SB-GA8-2021-208

Service Bulletin

Installation of a HAFEX (Halon Alternative Fire Extinguisher)

Figure 1 – Horizontal Mounting of Fire Extinguisher

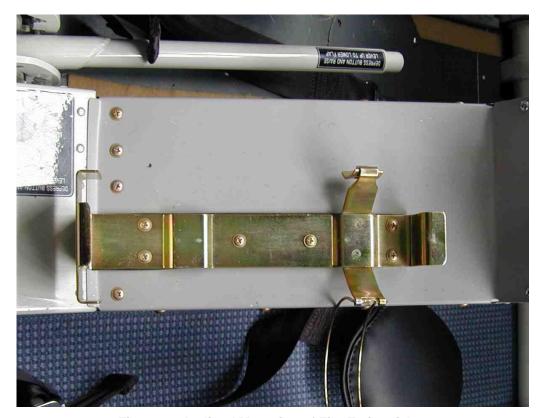
- 1. Remove Chubb 103335 BCF Fire Extinguisher unit from bracket by unlatching the two straps.
- 2. Uninstall the Chubb mounting bracket by removing the 4 x AN525-10R6 screws.
- 3. Fasten item 2, the Umlaut P3APP003020B, bracket in the same location using 4 x item 4, AN525-10R6 screws, from previous installation if serviceable, and 4 x item 3, AN970-4 washers.
- 4. Mount item 1, the Umlaut P3APP003010D, Fire Extinguisher unit to the installed bracket by latching the two straps, ensure the pressure gauge is visible for inspection.

Figure 3

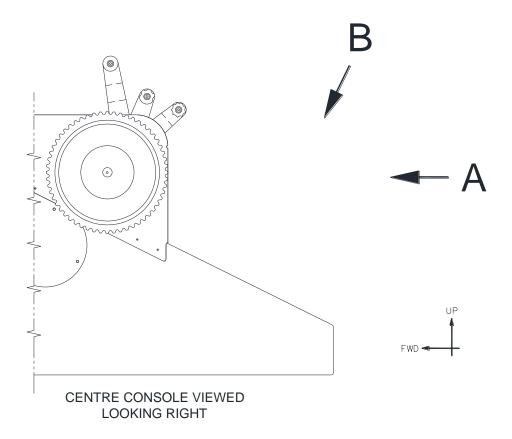
- 1. Remove the BCF Fire Extinguisher unit from bracket by unlatching the strap(s).
- 2. Uninstall the previous mounting bracket by removing the screws.
- 3. Mark the position of the lower right hand hole in the location depicted in Figure 4 (View B).
- 4. Use item 2, the Umlaut P3APP003020B, bracket as a template to mark the other three hole locations using the holes with the red circles as shown in Figure 3.

Figure 4

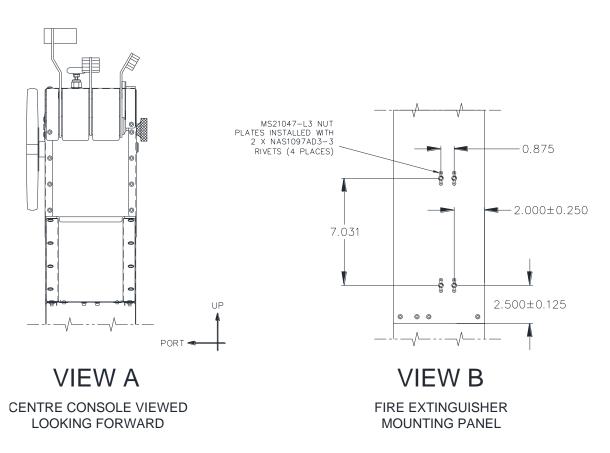
- 5. Drill the four holes using a #9 drill (0.196 inches).
- 6. Use item 5, MS21047-L3 nut plates, as a template to mark the locations for the two rivets holes either side of the 0.196" holes, as depicted in Figure 4 (View B).
- 7. Drill the eight holes using a #40 drill (0.098 inches).
- 8. Gain access to the underside of the inclined panel on the centre console via access panels.
- 9. Install 4 x item 5, MS21047-L3 nut plates, using 8 x item 6, NAS1097AD3-3 rivets.
- 10. Re-fit access panels.
- 11. Fasten item 2, the Umlaut P3APP003020B, bracket onto the nut plates using 4 x item 4, AN525-10R6 screws, and 4 x item 3, AN970-4 washers.
- 12. Mount item 1, the Umlaut P3APP003010D, Fire Extinguisher unit to the installed bracket by latching the two straps, ensure the pressure gauge is visible for inspection.

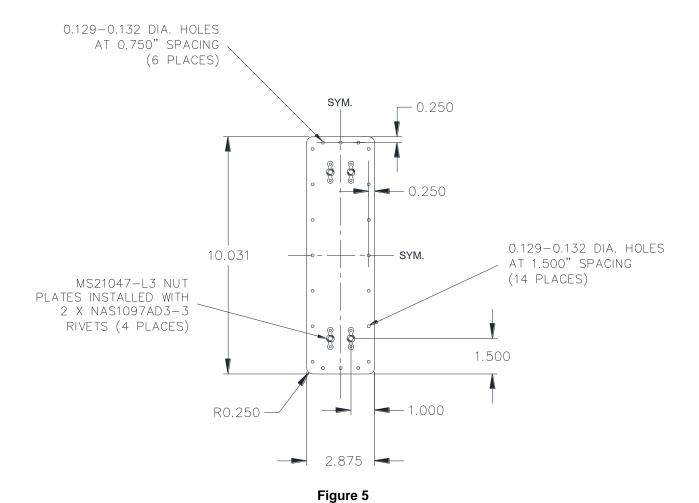
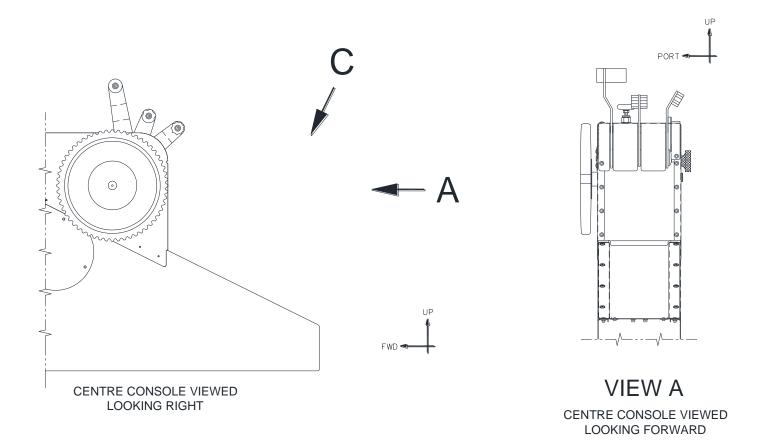
- 1. Fabricate a doubler from Aluminium Alloy 2024-T3 QQ-A-250/5 of 0.040" gauge in accordance with the dimensions in Figure 5. Prime the doubler with MIL-PRF-23377 Type I or II, Class C2 or equivalent, then topcoat the external surface with MIL-PRF-85285 Type I, Class H or equivalent. For reference the factory standard colour is Satin Horizon Grey.

- 2. Mark the fastener hole on the lower right of the doubler in the location depicted in Figure 5, then use item 2, the Umlaut P3APP003020B, bracket as a template to mark the other three hole locations using the holes with the red circles as shown in Figure 3. Drill the four holes using a #9 drill (0.196 inches). Use item 5, MS21047-L3 nut plates, as a template to mark the locations for the two rivets holes either side of the 0.196" holes, as depicted in Figure 5. Drill the eight holes using a #40 drill (0.098 inches).

- 3. Install 4 x item 5, MS21047-L3 nut plates, using 8 x item 6, NAS1097AD3-3 rivets. Drill 20 rivet holes with 0.129 to 0.132 inch diameter and 0.25 inch edge distance, 7 on each long side, starting from the lateral centreline at 1.5 inch spacing, and 3 on each short side, starting from the longitudinal centreline, at 0.75 inch spacing. Countersink the 20 rivets holes to 100°.

Figure 6

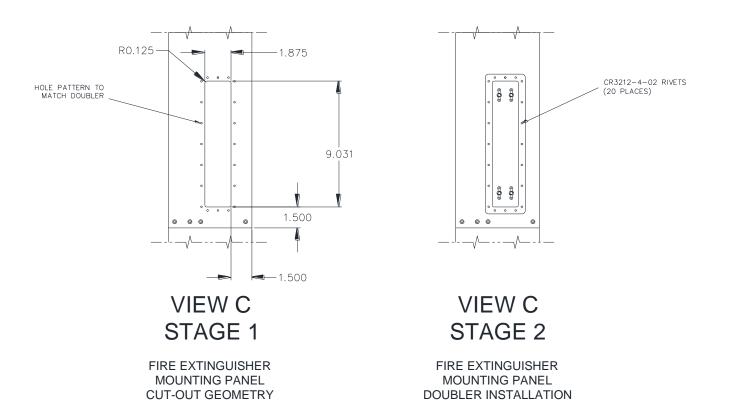
- 6. Carefully create the cut-out depicted in Figure 6.
- 7. Attach the doubler to the inclined panel on the centre console using 20 x item 7, CR3212-4-02 rivets.
